TECHNICAL NOTE

Galilee Power Project

SUBJECT: Response to TMR's Request for Further Information

Figure 1: SIDRA Intersection Model Layout – Capricorn Highway / Saltbush Road

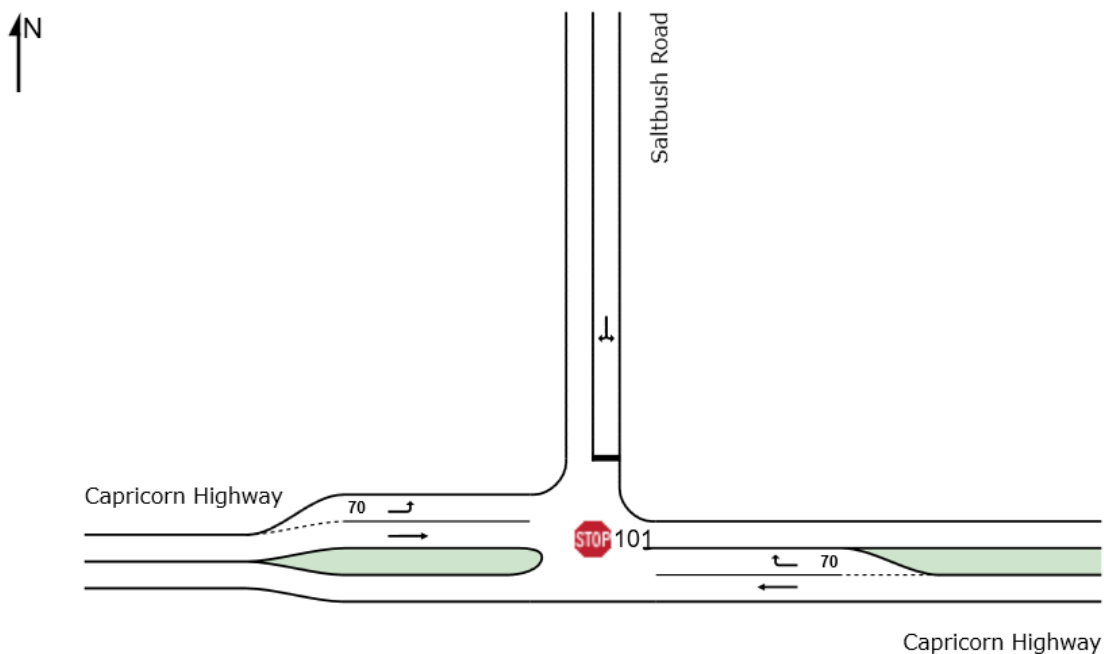
- *Item 22: TMR stated that the proposed CHR(S) urban treatment is insufficient as it appears to be based on a deceleration length for an 80km/hr design speed limit and vehicle storage to accommodate a B-Double. In this instance, the design speed should be 110km/hr and storage should at minimum accommodate a Type 1 Road Train as per the proposed de-sulphuring solution.*
- *Item 23: The average amount of queued vehicles should be determined from a SIDRA analysis.*
- *Item 24: Although TMR have no issues with the proposed installation of boom gates, the report has not accounted for and demonstrated that vehicles can be safely stored between the rail crossing and state-controlled road.*

23. The average amount of queued vehicles should be determined from a SIDRA analysis.
24. Although DTMR have no issues with the proposed installation of boom gates, the report has not accounted for and demonstrated that vehicles can be safely stored between the rail crossing and state-controlled road.

SIDRA analysis has been undertaken to ensure suitability of the intersection layout when subject to the anticipated traffic volumes. The assessment utilised the largest anticipated peak hour traffic volumes projected to use the Capricorn Highway / Saltbush Road intersection, corresponding with Option 3 of the flue gas desulphurisation (FGD) process. Detailed description of the haul movement options can be found in GTA's TIA.

The SIDRA model corresponds with the concept design provided in Attachment 3 and is shown in Figure 1.

The proposed intersection layout is anticipated to perform well within acceptable service thresholds with regards to average delay, degree of saturation and 95th percentile queue lengths. Results of the assessment are shown in Table 1 with detailed outputs provided in Attachment 5.
